To: Stephen Pendl, Vera Development

Project Description: Zhanna Place

Project/File: **Zhanna Place / GCPP24-0005 / SUBFY2024-0005**

This is a preliminary plat application to allow for the development of a 10-lot subdivision, consisting of 9 residential lots and 1 common lot on .7 acres.

C. Site Plan

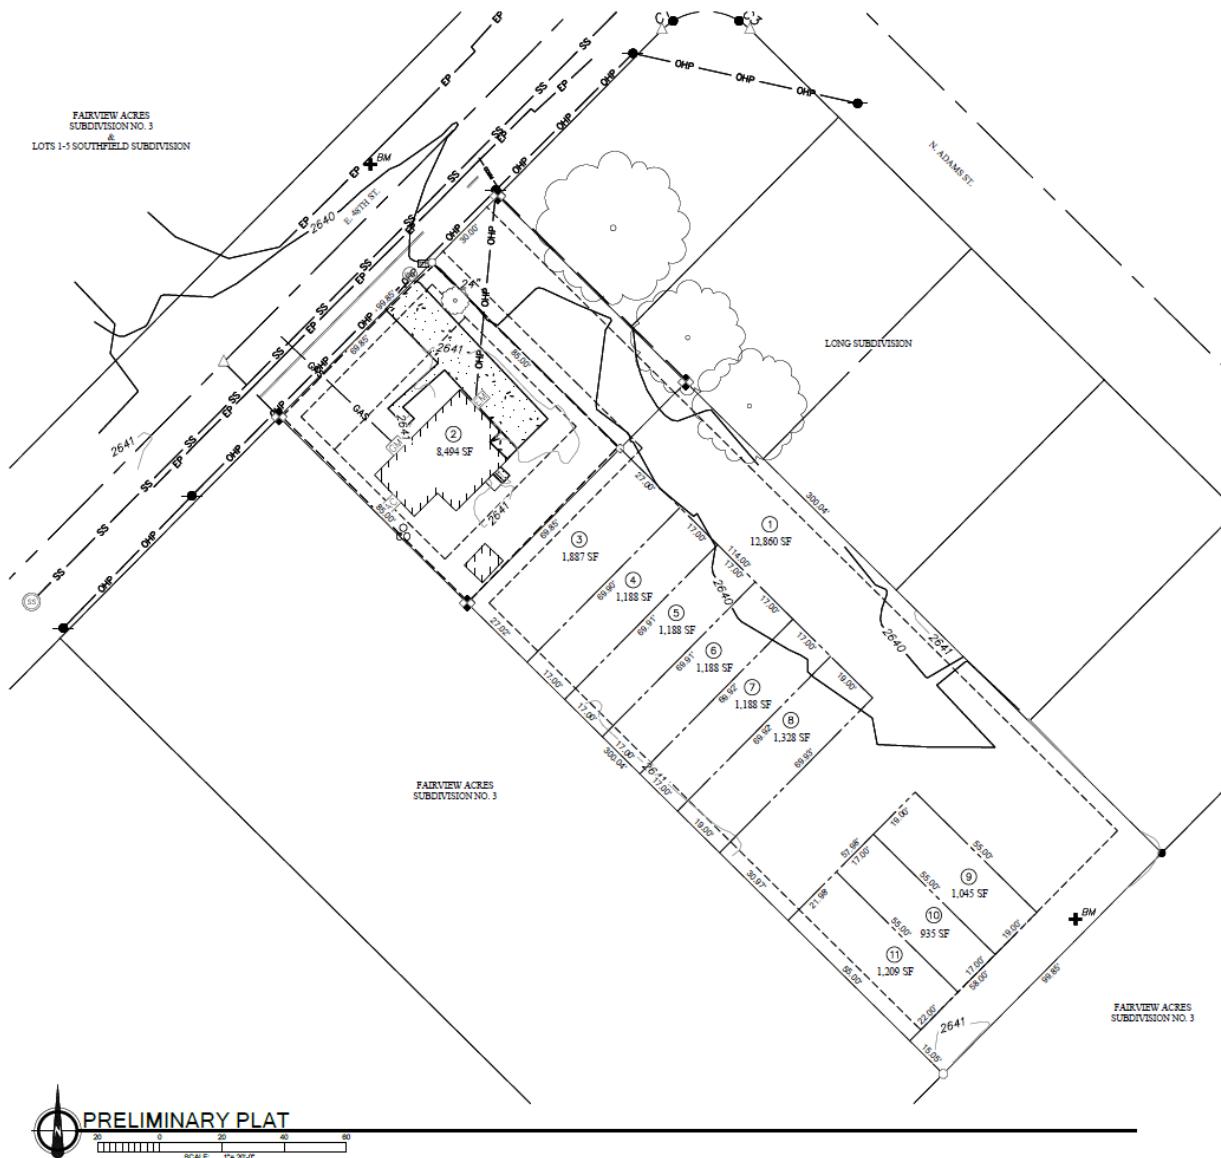
1. Improve 48th Street as ½ of a 33-foot wide local street section with curb, gutter, an 8-foot wide landscape strip, and 5-foot wide detached concrete sidewalk abutting the site.
2. Construct a 20-foot wide paved driveway from the site onto 48th Street, located 140-feet southwest of Adams Street.
3. Submit civil plans to ACHD Development Services for review and approval. The impact fee assessment will not be released until the civil plans are approved by ACHD.
4. There will be an impact fee that is assessed and due prior to issuance of any building permits. The assessed impact fee will be based on the impact fee ordinance that is in effect at that time. The impact fee assessment will not be released until the civil plans are approved by ACHD.
5. Comply with all Standard Conditions of Approval.

- a. Existing Conditions:** 48th Street is improved with 2-travel lanes, 26-feet of pavement and no curb, gutter or sidewalk abutting the site. There is 50-feet of right-of-way for 40th Street (25-feet from centerline).
- b. Applicant's Proposal:** The applicant is proposing to improve 48th Street as ½ of a 33-foot wide local street section with curb, gutter, an 8-foot wide landscape strip, and 5-foot wide detached concrete sidewalk abutting the site.
- c. Staff Comments/Recommendations:** The applicant's proposal meets District policy and should be approved, as proposed. Provide a permanent right-of-way easement for detached sidewalks located outside of the dedicated right-of-way.

- a. Existing Conditions:** There are no existing driveways from the site onto 48th Street.
- b. Applicant's Proposal:** The applicant is proposing to construct a 20-foot wide driveway from the site onto 48th Street, located 140-feet southwest of Adams Street.
- c. Staff Comments/Recommendations:** The applicant's proposal meets District policy and should be approved, as proposed. The driveway should be constructed as a paved curb-cut type driveway.
